Attorney Docket No. 0388-043890

## **AMENDMENTS TO THE DRAWINGS**

Katsuhiko Uemura et al. Application No. 10/823,532 "Four-Wheel Drive Work Vehicle" Attorney Docket No. 0388-043890 ANNOTATED SHEET

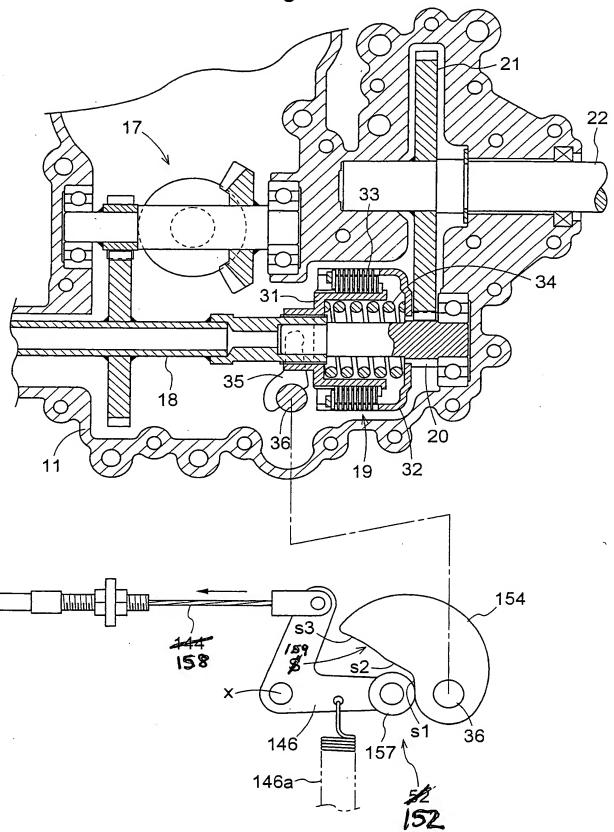
"137" has been changed to "152" in Figs. 12 and 17;

"138" has been changed to "154" in Figs. 12 and 17;

"139" has been changed to "146" in Fig. 12 and 17;

"147" has been changed to "158" in Figs. 12 and 17;

Fig.13

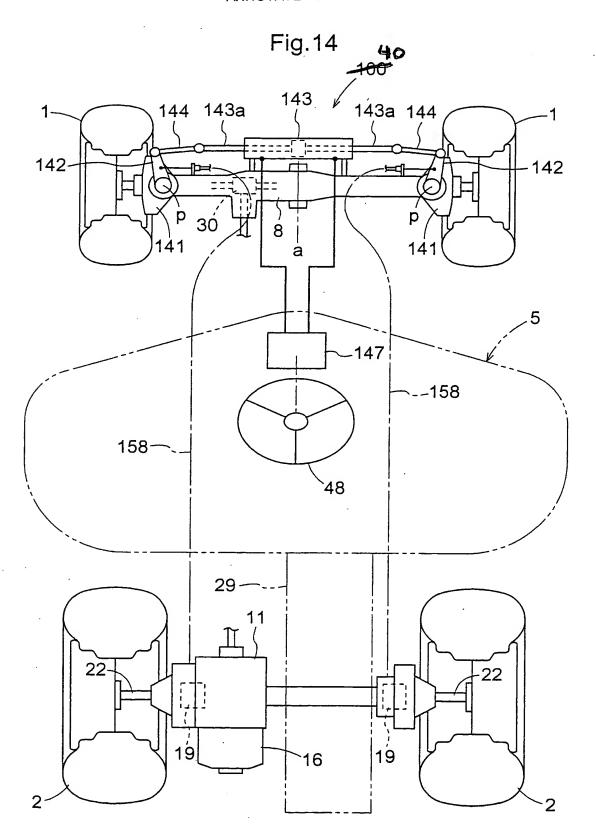
"S" has been changed to "159" in Fig. 13;

"52" has been changed to "152" in Fig. 13;

"144" has been changed to "158" in Fig. 13;

Fig.15

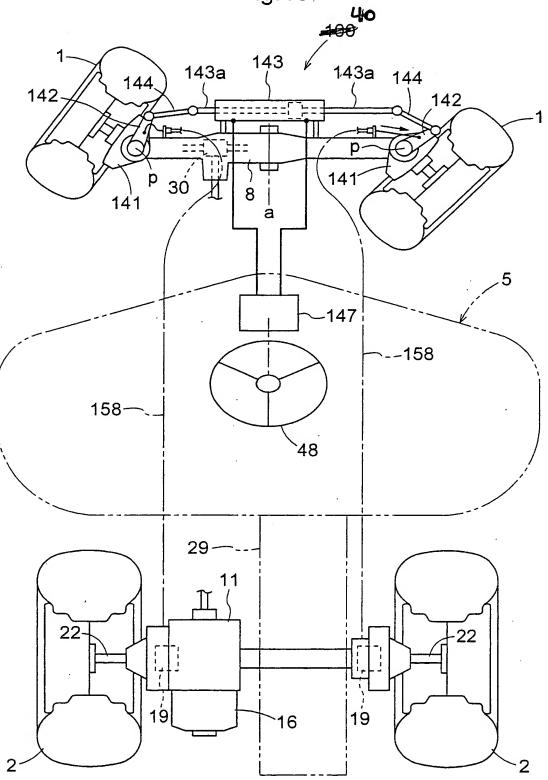
"100" has been changed to "40" in Figs. 14 and 15;

Fig.17

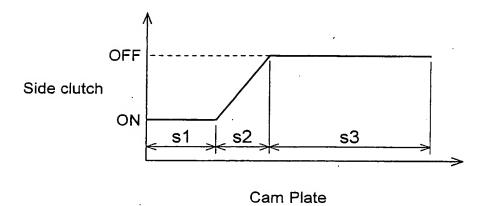
"139a" has been changed to "157" in Fig. 17; and

"148" has been changed to "146a" in Fig. 17.
